To:	Karyn Lewis Lupin Mine Incorporated	From:	Alvin Tong Stantec Consulting Ltd.
File:	Supporting Information for the Dam Stability and Cover Design	Date:	January 10, 2020

Reference: Supporting Information for the Dam Stability and Cover Design

PHC COMMENTS RESPONSE

TAILINGS CONTAINMENT AREA
CELL 3 COVER AND SURFACE
WATER MANAGEMENT

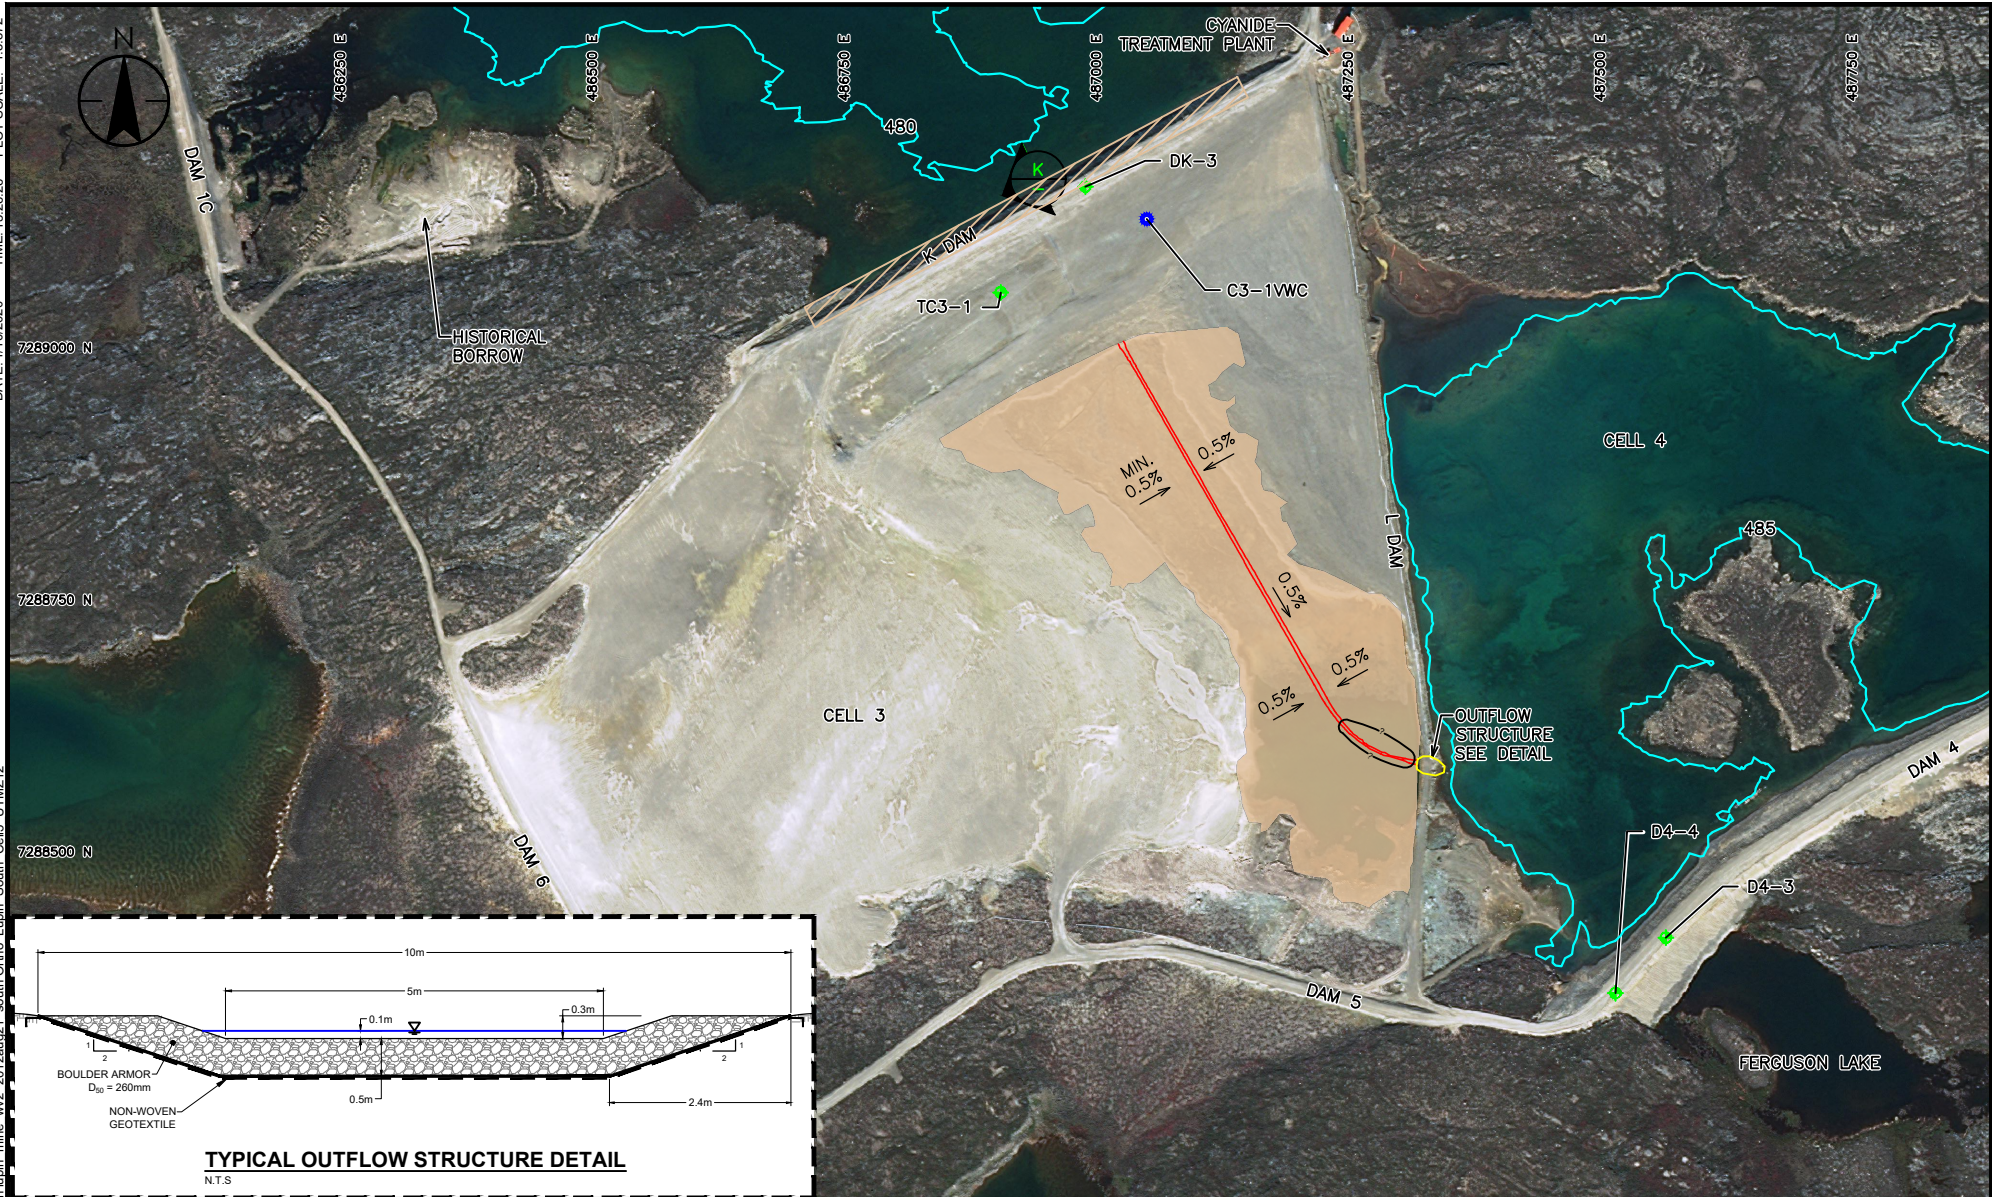
The original response to the commitment was provided on November 14, 2019. Follow up comments and a meeting with CIRNAC on January 7th, 2020 identified that additional information is needed to provide details for the resloping for Dam K and M. The figures provided herein is revised from the original submission in November 2019 to provide the additional information as requested in the January meeting.
